IN THE DRAWINGS:

REMARKS

This Amendment is submitted in response to the Office Action dated February 9, 2006 and the Office Communication dated July 7, 2006. In the Office Action, the Patent Office objected to Claim 69 under 37 CFR §1.75 as being a substantial duplicate of Claim 67. Additionally, the Patent Office objected to the disclosure for informalities. Further, the Patent Office rejected Claims 8-13 under 35 U.S.C. §112, first paragraph, as containing subject matter which was not described in the specification in such a way as to reasonably convey to one skilled in the relevant art that the inventor, at the time the application was filed, had possession of the claimed invention.

FIG. 7

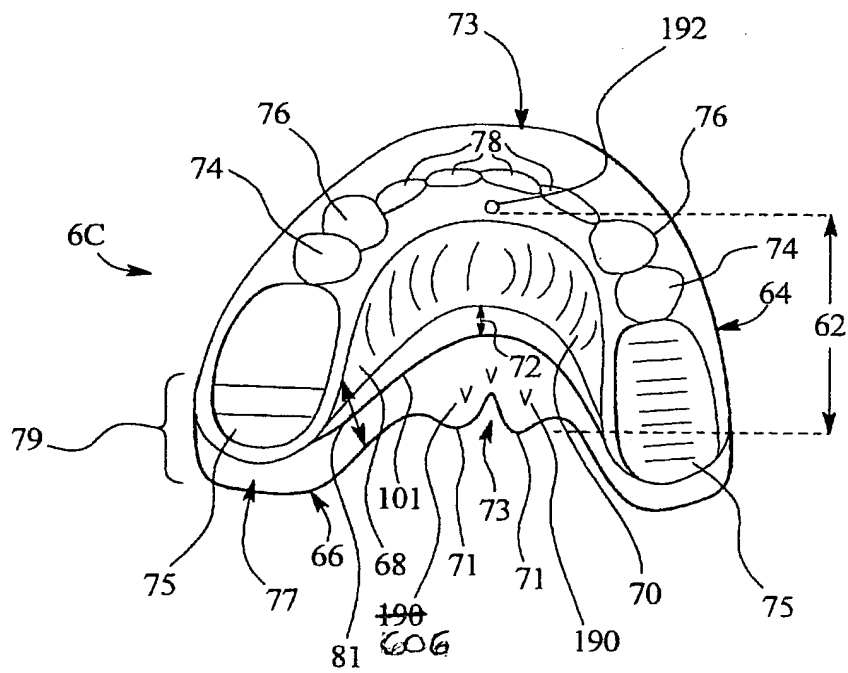
FIG. 7 has been corrected as shown in the Replacement Drawing Sheet and as shown in red in the Annotated Sheet Showing Changes in the attached Appendix.

Reference numeral 104 refers to a lower shell (page 40, line 18) and an upper incisor (page 40, line 27). Reference numeral 190 refers to spikes (page 38, line 31) and an appliance (page 40, line 33). Reference numeral 329 refers to sockets (page 53, line 31) and a front section (page 54, line 5). Reference 317 refers to sockets (page 54, line 7) and upper front teeth (page 54, line 7).

Applicant also submits herewith corrections to FIGS. 7, 10A and 29A to replace the reference sign "190" with the reference sign "606" to identify the spikes 606, to replace the reference sign "104" with the reference sign "604" to identify an upper incisor 604 and to replace the reference sign "329" with the reference sign "608", respectively, as shown in the Replacement Drawings Sheets and as shown in red in the Annotated Sheets Showing Changes in the attached Appendix.

FIG. 10A

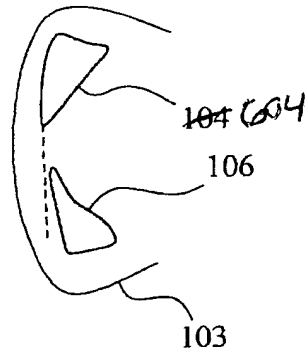
FIG. 10A has been corrected as shown in the Replacement Drawing Sheet and as shown in red in the Annotated Sheet Showing Changes in the attached Appendix.
